Access Compliance Report

Public Rights-of-Way

Intersection ID: 7025	Main Street: HUTCHISON-MCDONALD_RD	Cross Street: STATESVILLE_RD	Location: SE
ADA ID: 8CF30B0D2DDD	Ramp Type: Perp	Initial Pass/Fail: Pass	Overall Compliance: No
		Severity Score: 0	
Codes/Mitigation Info/Possible Solution		Field Measurements/Component Compliance

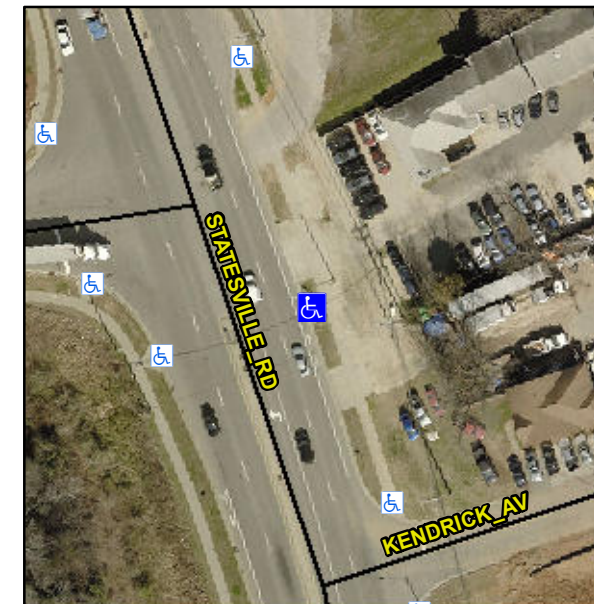
Not Found, R302.7

Compliance	Description	Data	Compliance	Description	Data
N/A	Ramp Length (in)	94.0	Yes	Ramp Slope (%)	8.1
Yes	Ramp Width (in)	48.0	Yes	Ramp XSlope (%)	0.7
N/A	Flare Type LT	Sloped	N/A	Flare Type RT	N/A
N/A	Flare Slope LT (%)	9.8	N/A	Flare Slope RT (%)	10.1
N/A	Flare Traversable LT?	No	N/A	Flare Traversable RT?	No
Yes	Landing Length (in)	72.0	Yes	DWS Provided?	Yes
Yes	Landing Width (in)	48.5	Yes	DWS Contrast?	Yes
Yes	Landing Slope (%)	1.4	Yes	DWS Length (in)	24.0
Yes	Landing X Slope (%)	0.4	Yes	DWS Full Width?	Yes
N/A	Landing Curb? (Y/N)	No	Yes	DWS Offset (in)	1.0
N/A	Shared Landing?	No			
No	Gutter Ponding?	Yes	Yes	Gutter Slope (%)	1.3
Yes	Gutter Lip Ht (in)	0.0	Yes	Gutter X Slope (%)	0.3
N/A	Painted X Walk1?	No	N/A	Painted X Walk2?	N/A
	X Walk 1 Direction	To W		X Walk 2 Direction	N/A
N/A	X Walk 1 Width (in)	N/A	N/A	X Walk 2 Width (in)	N/A
	X Walk 1 Slope (%)	0.5		X Walk 2 Slope (%)	N/A
	X Walk 1 X Slope (%)	0.4		X Walk 2 X Slope (%)	N/A

N/A	Ramp inside XWalk1?	N/A	N/A	Ramp inside XWalk2?	N/A
	Road Slope (%)	N/A	N/A	Clear Space?	Yes
	Road X Slope (%)	N/A	N/A	Clear Space to XWalk (in)	N/A
Yes	Any Obstructions?	No	Yes	Storm Grate/Utility Hazard?	No
	Obstruction Type			Storm Grate/Utility Type	
		N/A			N/A
			Yes	Surface Condition? (G/P)	Good

Remove & Replace Entire Ramp.
